# LIVING BREAKWATERS CAC MEETING

05/xx/2021

Governor's Office of  
Storm Recovery

# Minor Design Changes

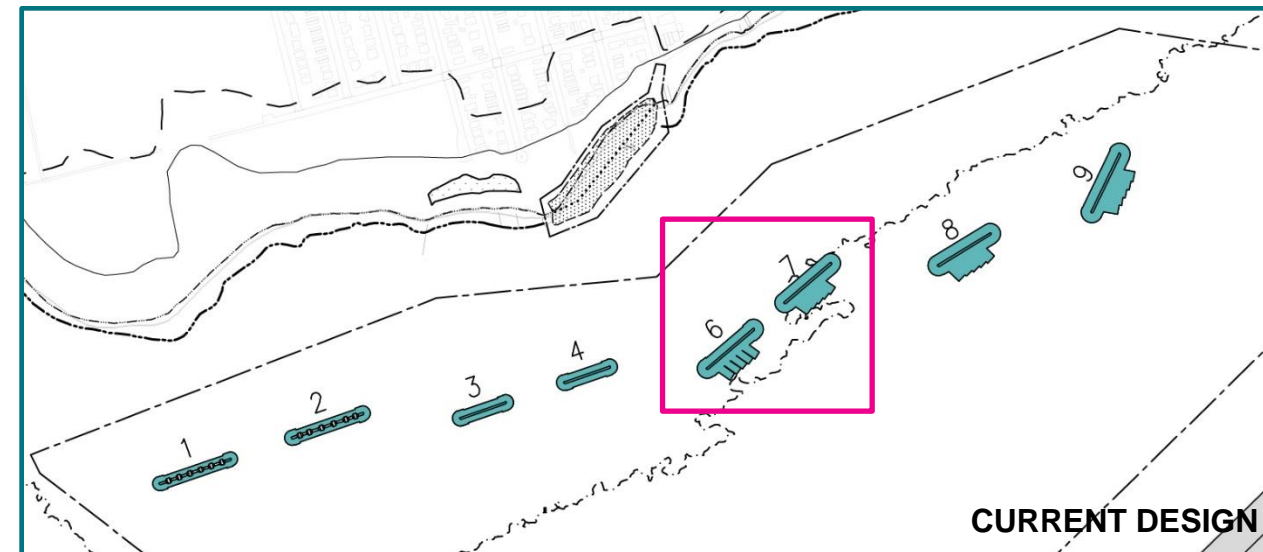
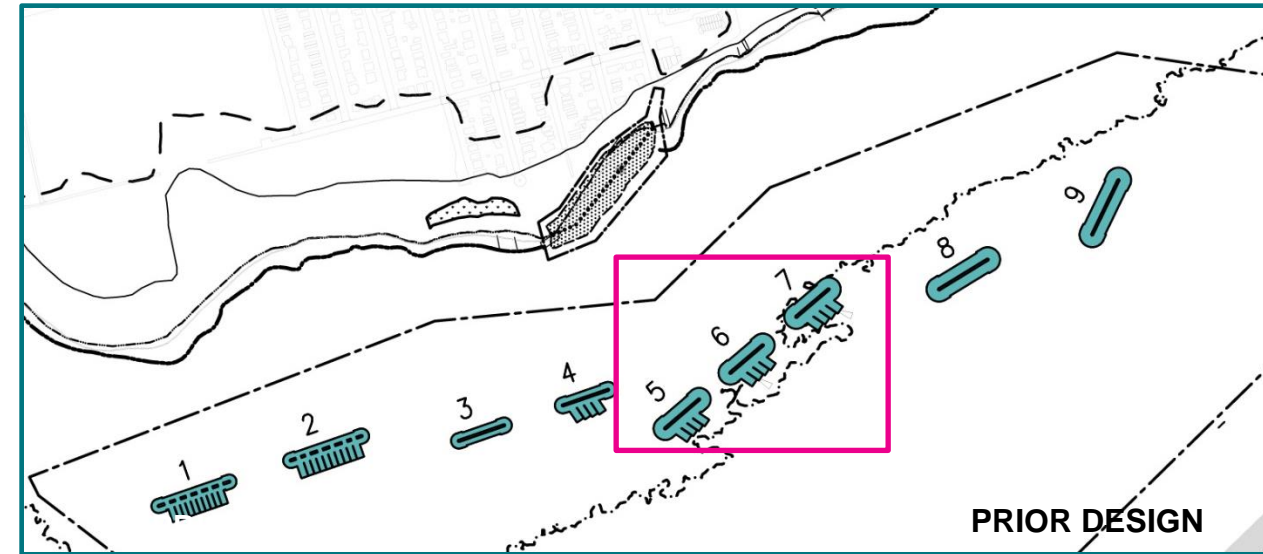
- **Eliminated a breakwater by consolidating three breakwaters into two**
- Reduced crest height of tallest breakwaters
- Reduced number of reef ridges and eco-concrete units
- Replaced some structural materials
- Adjusted some seasonal restriction requirements
- Provided additional time (2 years to 4 years)

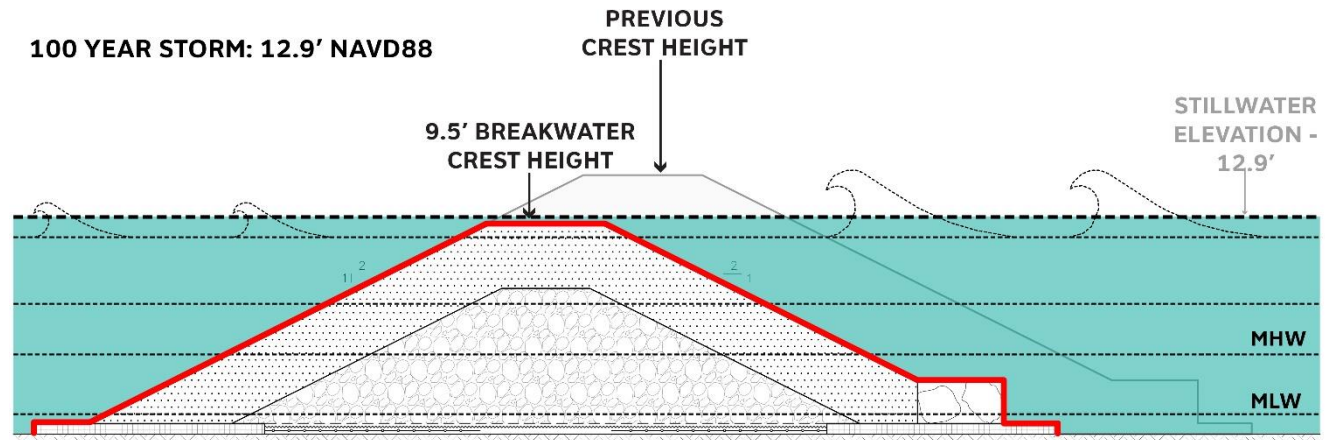
- Eliminated a breakwater by consolidating three breakwaters into two
- **Reduced crest height of tallest breakwaters**
- Reduced number of reef ridges and eco-concrete units
- Replaced some structural materials
- Adjusted some seasonal restriction requirements
- Provided additional time (2 years to 4 years)

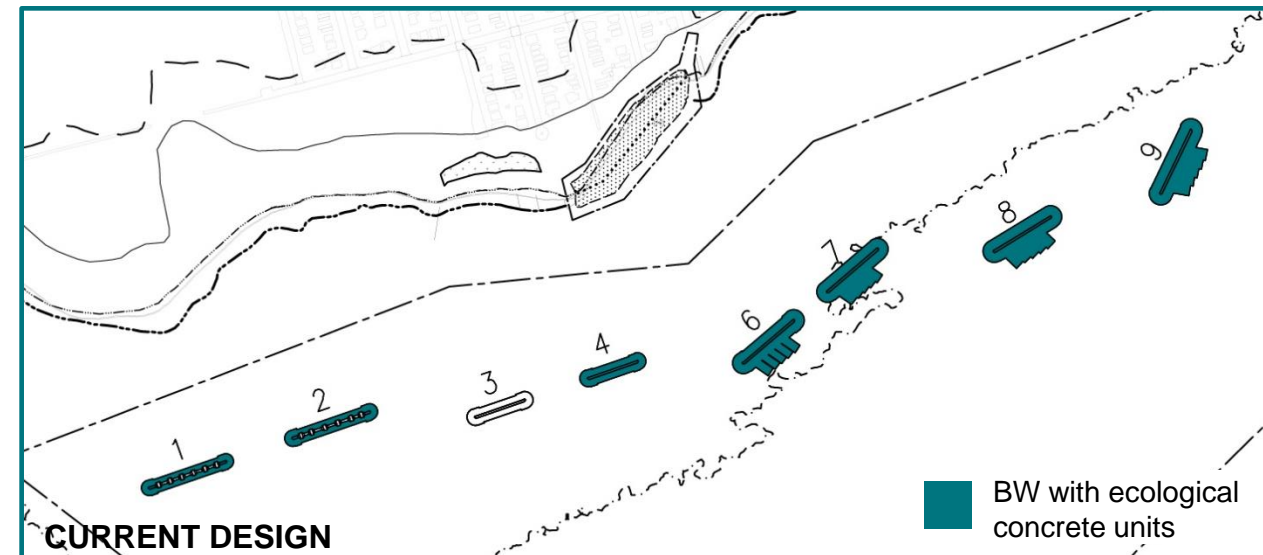
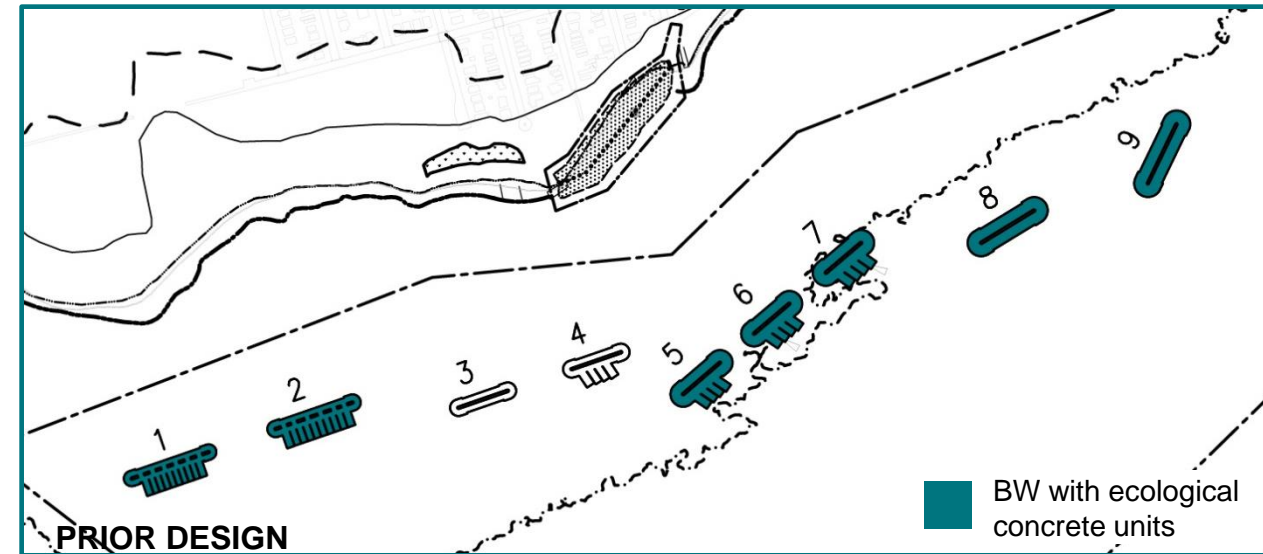
- Eliminated a breakwater by consolidating three breakwaters into two
- Reduced crest height of tallest breakwaters
- **Reduced number of reef ridges and eco-concrete units**
- Replaced some structural materials
- Adjusted some seasonal restriction requirements
- Provided additional time (2 years to 4 years)

**BREAKWATER 7  
PRIOR DESIGN**

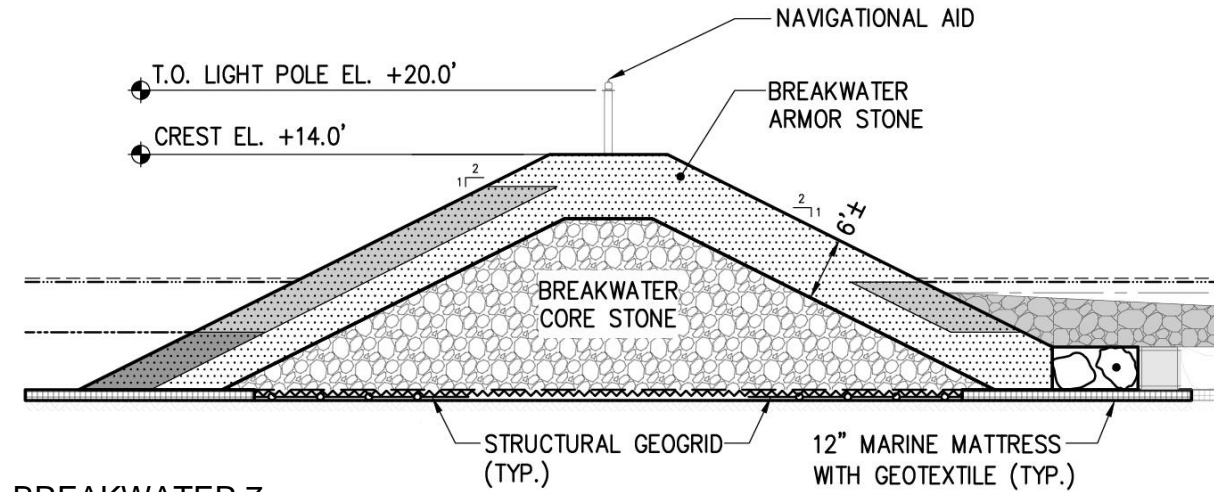
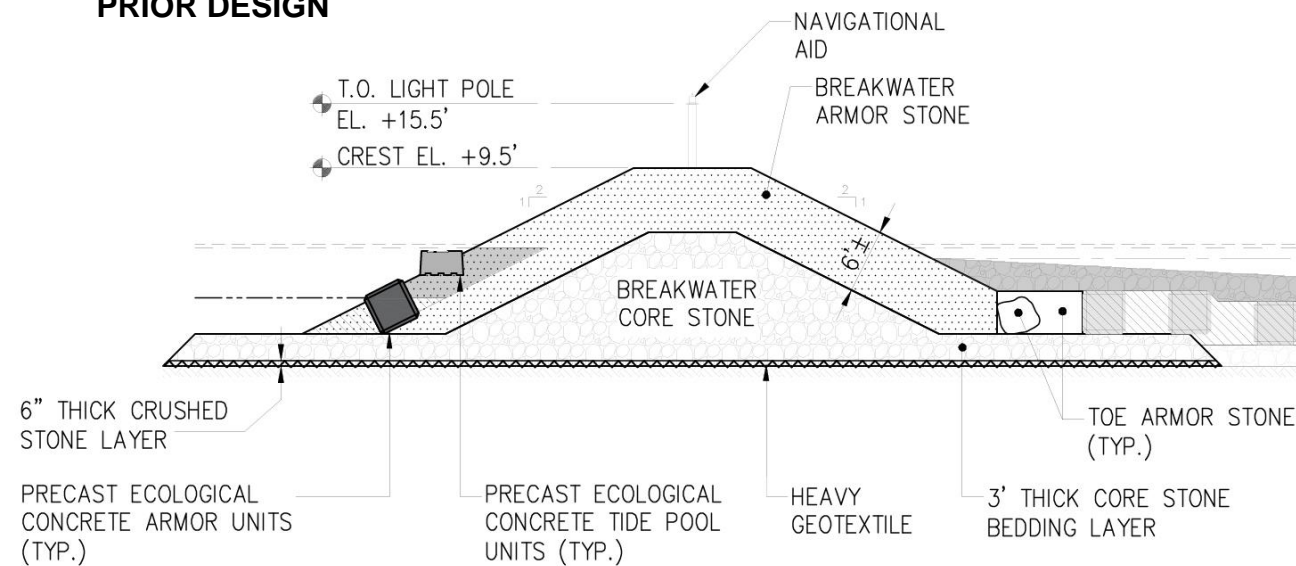
- Eliminated a breakwater by consolidating three breakwaters into two
- Reduced crest height of tallest breakwaters
- Reduced number of reef ridges and eco-concrete units
- **Replaced some structural materials**
- Adjusted some seasonal restriction requirements
- Provided additional time (2 years to 4 years)

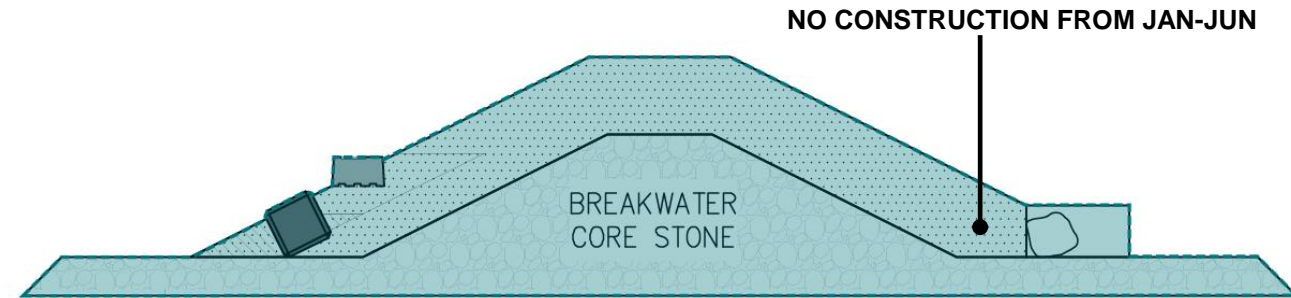
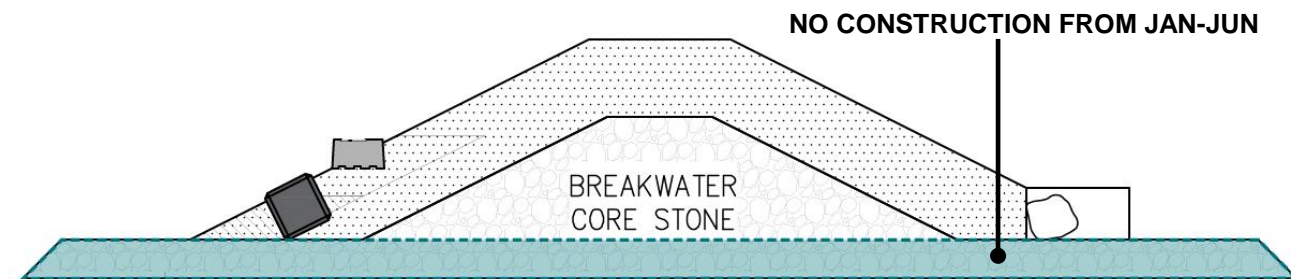
- Eliminated a breakwater by consolidating three breakwaters into two
- Reduced crest height of tallest breakwaters
- Reduced number of reef ridges and eco-concrete units
- Replaced some structural materials
- **Adjusted some seasonal restriction requirements**
- Provided additional time (2 years to 4 years)

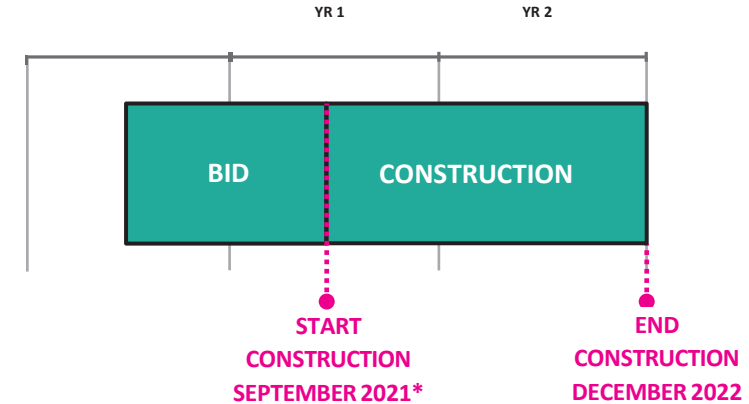
- Eliminated a breakwater by consolidating three breakwaters into two
- Reduced crest height of tallest breakwaters
- Reduced number of reef ridges and eco-concrete units
- Replaced some structural materials
- Adjusted some seasonal restriction requirements
- **Provided additional time for construction (2 years to 4 years)**

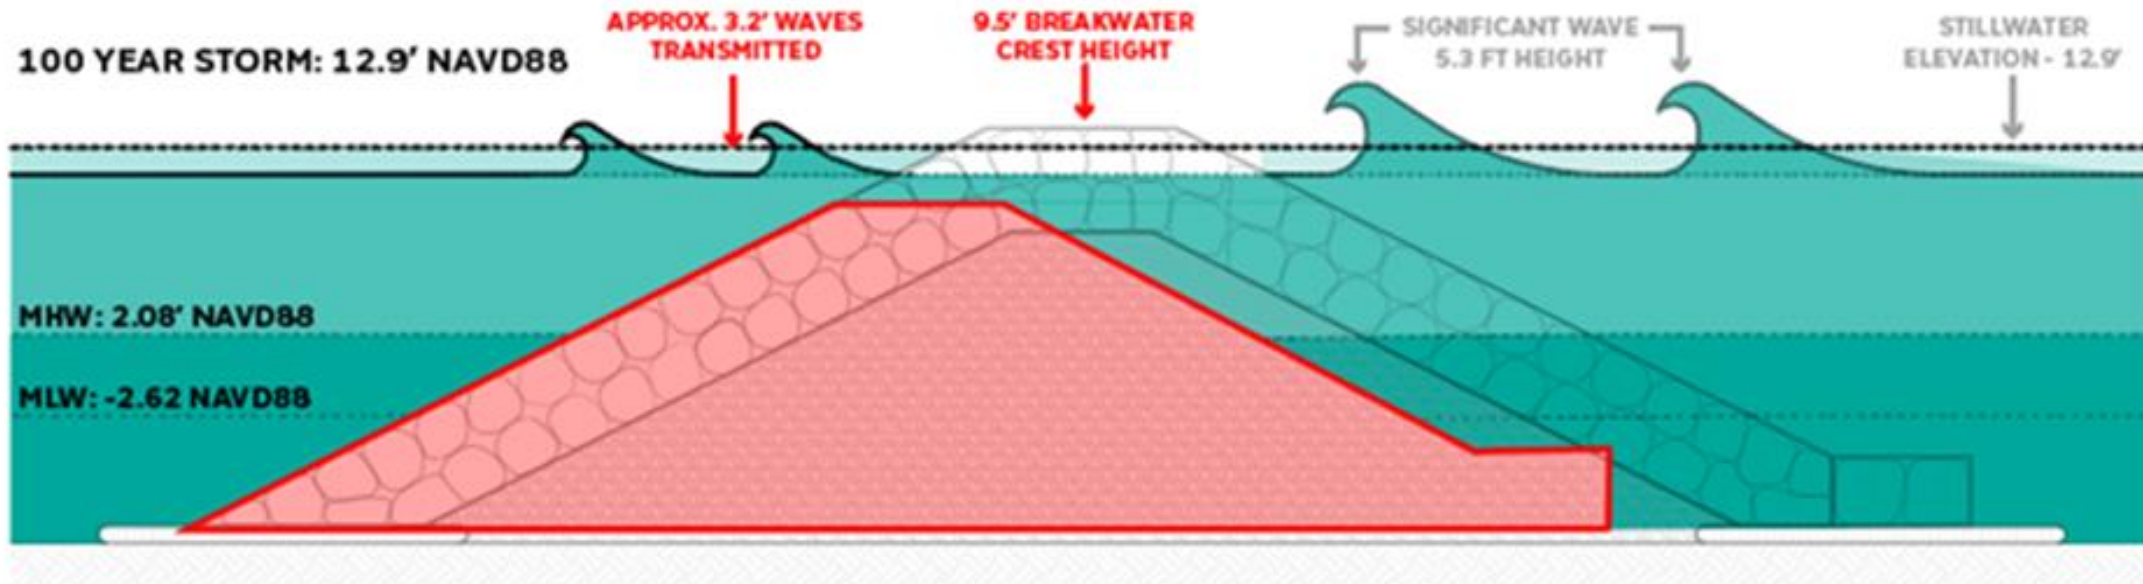
- Eliminated a breakwater by consolidating three breakwaters into two
  - **Reduced crest height of tallest breakwaters**
  - Reduced number of reef ridges and eco concrete units
  - Replaced some structural materials
  - Provided additional time (2 years to 4 years)
  - Adjust some seasonal restriction requirements
- 
- **Total Approximate Estimated Cost Savings: \$21 million**

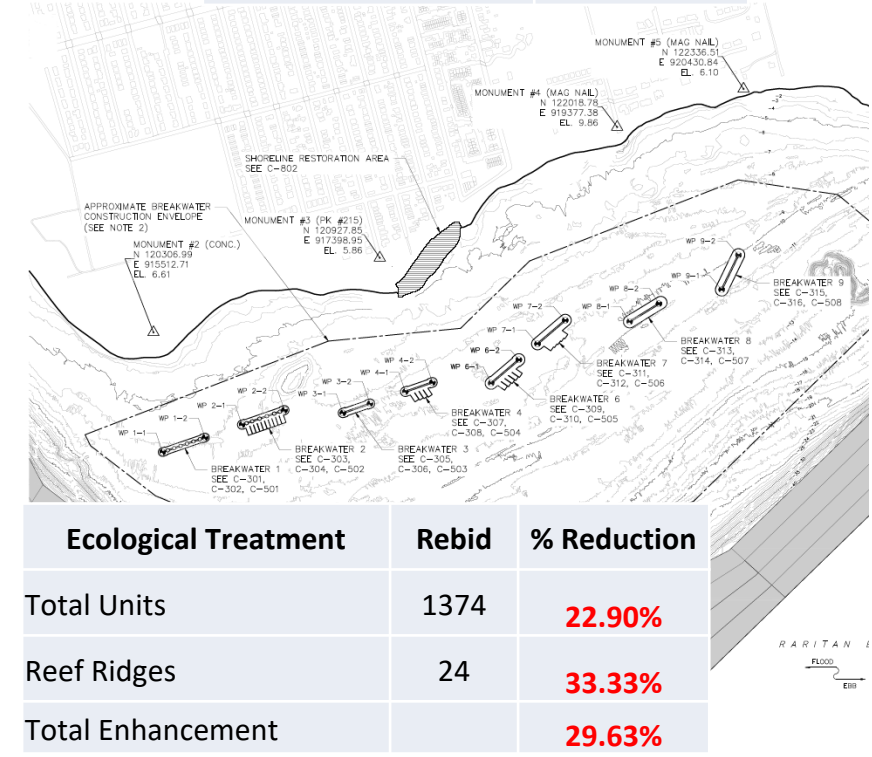
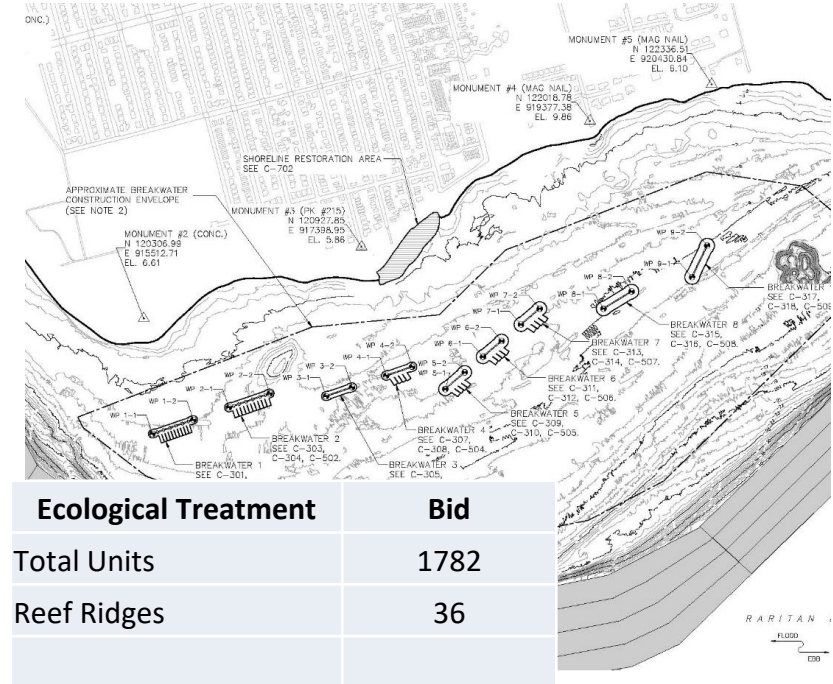
- Eliminated a breakwater by consolidating three breakwaters into two
- Reduced crest height of tallest breakwaters
- Reduced number of reef ridges and eco concrete units
- Replaced some structural materials
- Provided additional time (2 years to 4 years)
- Adjust some seasonal restriction requirements
- **Total Approximate Estimated Cost Savings: \$21 million**

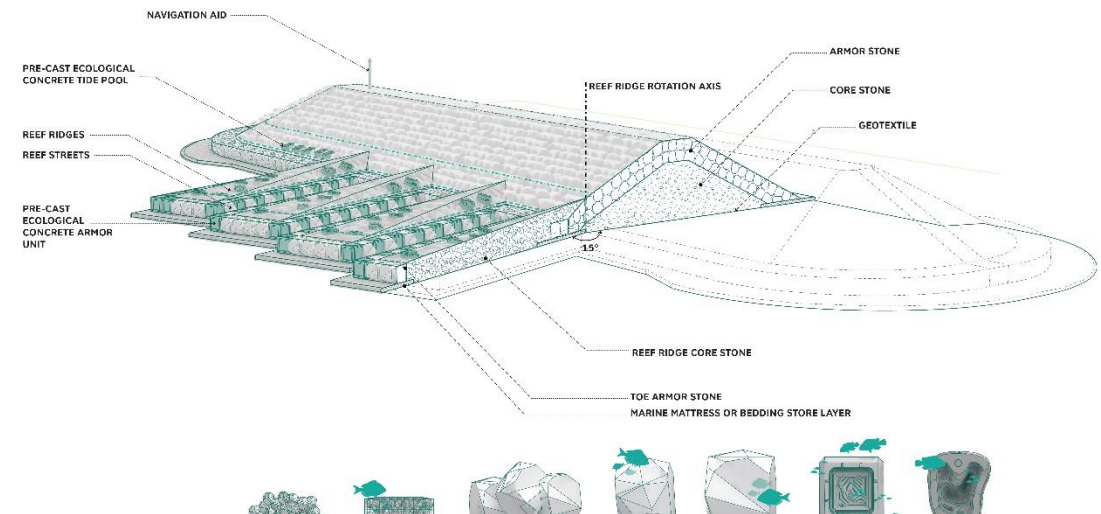
- Eliminated a breakwater by consolidating three breakwaters into two
  - Reduced crest height of tallest breakwaters
    - Reduced number of reef ridges from
  - Reduced number of eco-concrete units
    - **Replaced some structural materials**
  - Provided additional time (2 years to 4 years)
  - Adjusted some seasonal restriction requirements
